**Addendum**  
to the  
**U.S. 50/Ponderosa Road/South Shingle Road**  
**Interchange Improvements Project**  
**Initial Study/Mitigated Negative Declaration**  
**(SCH #2018012042)**

El Dorado County  
Department of Transportation  
2850 Fairlane Court  
Placerville, CA 95667

March 2025

## Proposed Addendum

Exhibit A

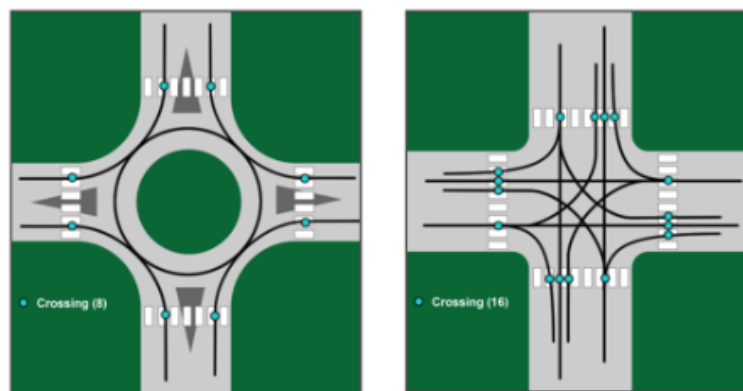
This Addendum proposes to amend the project features exhibit of the final Initial Study/Mitigated Negative Declaration (IS/MND) document to include the construction of roundabouts at the intersection of Ponderosa Road and North Shingle Road, and the at the intersection of South Shingle Road with Durock Road and Sunset Lane. Based on further traffic and air quality analysis since approval of the 2020 IS/MND, it was determined that roundabouts perform better operationally than the previously approved signalized intersection design by reducing traffic congestion and thereby pollution due to less idling (see Sections III Air Quality and XVI Transportation). Roundabouts were also selected for public safety purposes. Studies show that roundabouts significantly reduce severe crashes with up to a 40% reduction in total crashes and a 76% reduction in crashes resulting in injuries or fatalities by having fewer vehicle to vehicle and vehicle to pedestrian conflict points<sup>1</sup>. A five-year collision history for the Ponderosa Road/South Shingle Road corridor showed 13 injury-related collisions. Including roundabouts as a design feature is anticipated to reduce the number of vehicle and pedestrian/bicycle accidents at the intersection of Ponderosa Road and North Shingle Road, and the at the intersection of South Shingle Road with Durock Road and Sunset Lane.

#### Section 2.1.1.2 Parking

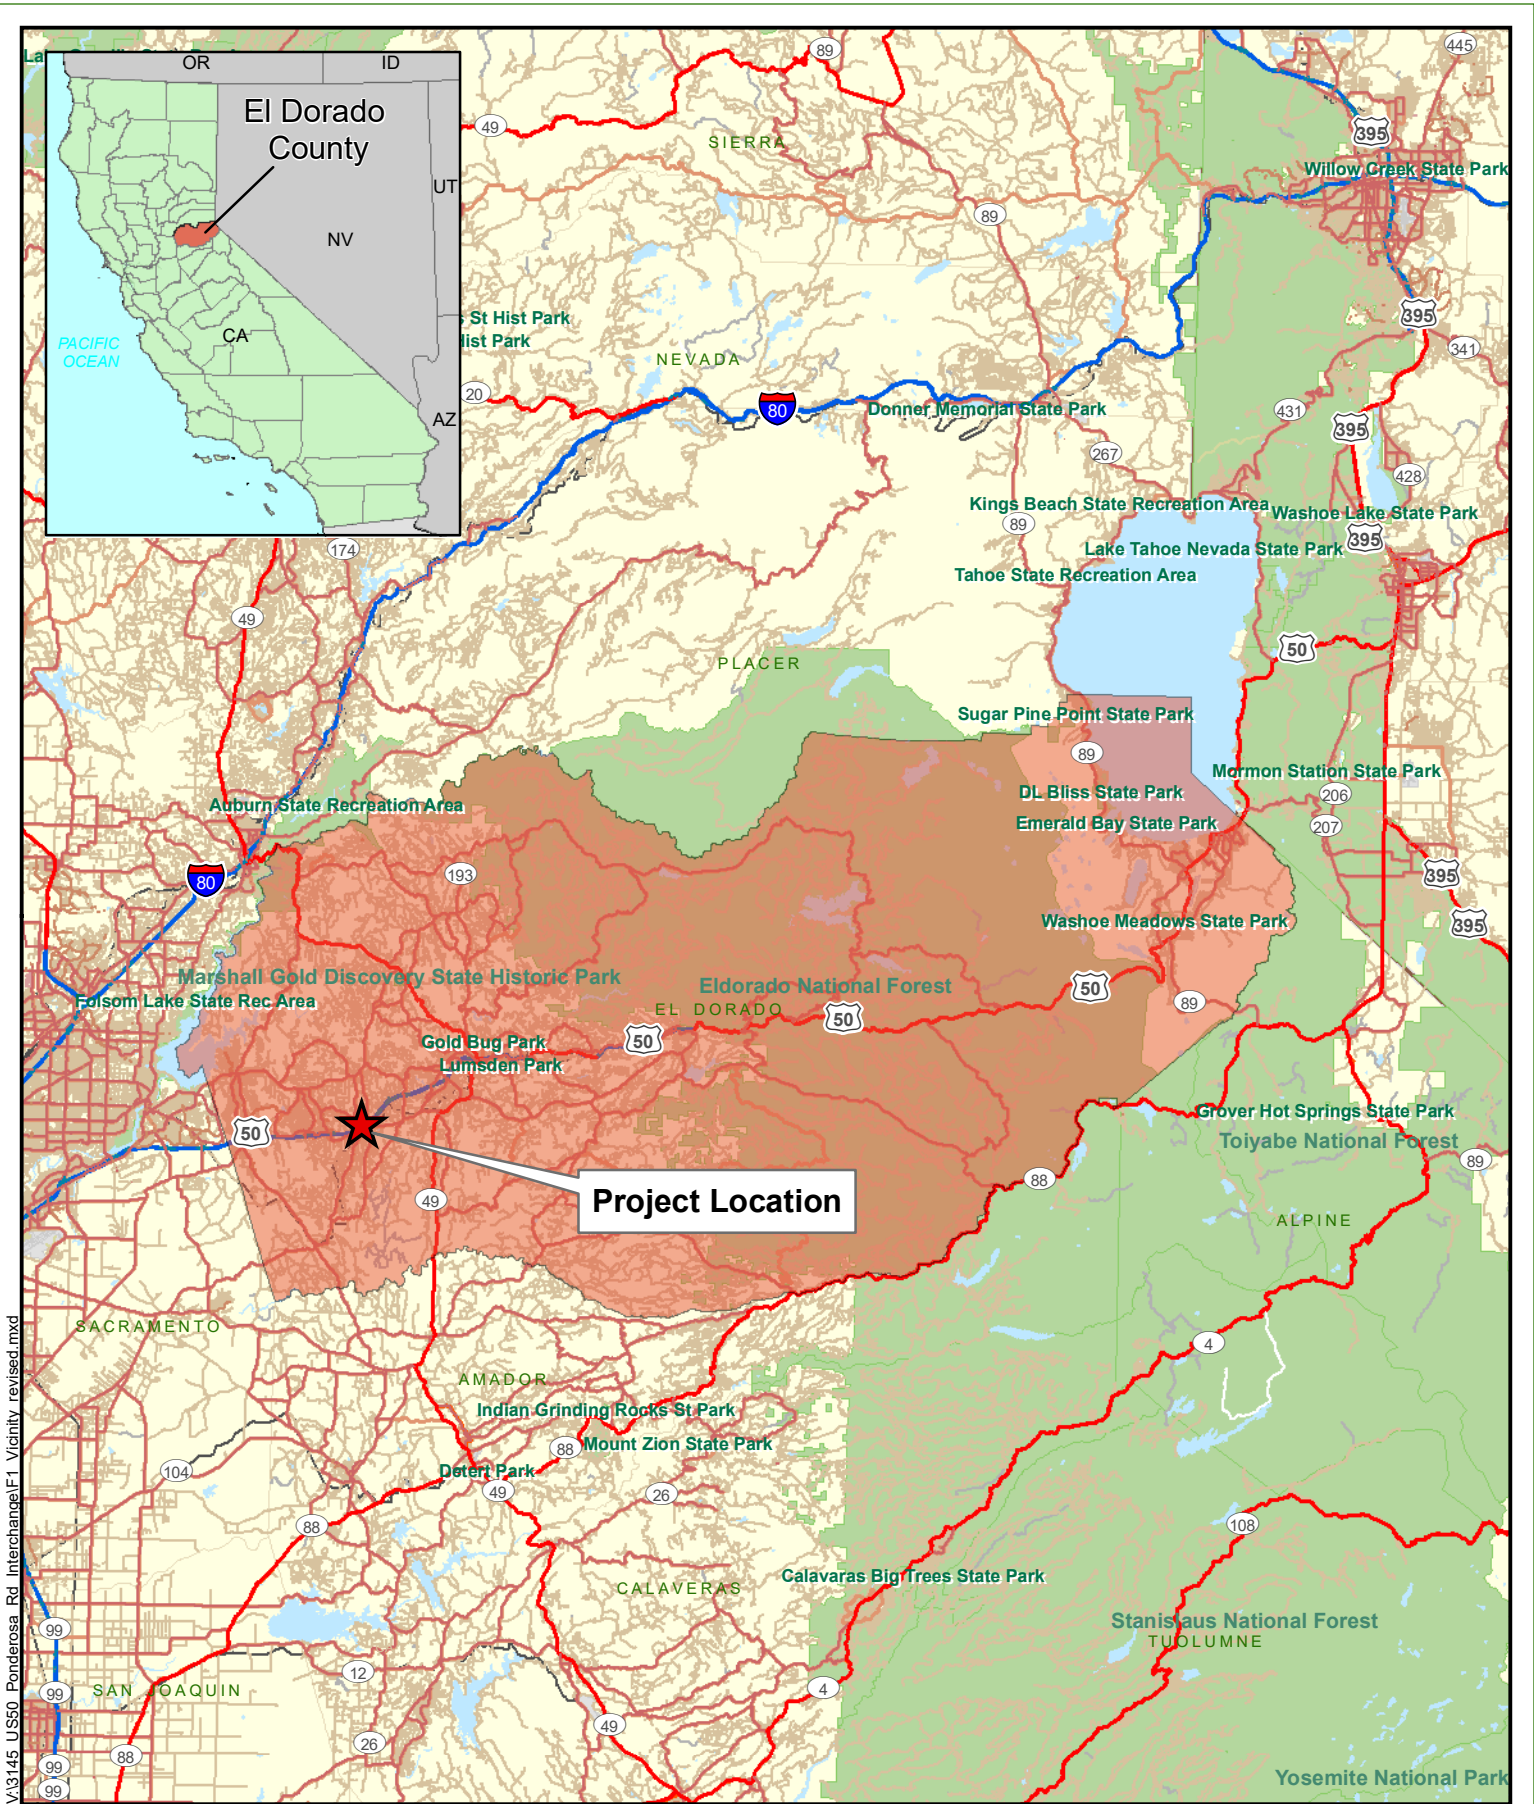
Lastly, pursuant to the 2023 El Dorado Transit Park-and-Ride Master Plan, the number of parking spaces in the northwest (Wild Chapparal), northeast (North Shingle Road), and southwest (Durock Road) parking lots has changed. The following revisions to Section 2.1.1.2 Parking has been updated to reflect the accurate number of spaces to be removed and replaced as a result of the proposed Project (Build Alternative 1):

Currently there are three park and ride facilities in the project area, located in the northwest, northeast, and southwest quadrants. The northwest lot has ~~413~~ 94 spaces, the northeast lot has ~~28~~ 18 spaces, and the southwest lot has ~~60~~ 44 spaces. Under Build Alternatives 1 and 2, improvements to the interchange on- and off-ramps and the realignment of North Shingle Road would eliminate the park and ride lot in the northeast quadrant which will result in a loss of ~~28~~ 18 parking spaces. Replacement spaces have been incorporated into the project design by adding ~~28~~ 18 spaces to the park and ride lot in the southwest quadrant. As a result, Build Alternatives 1 and 2 would not reduce the number of park and ride parking spaces in the project area.
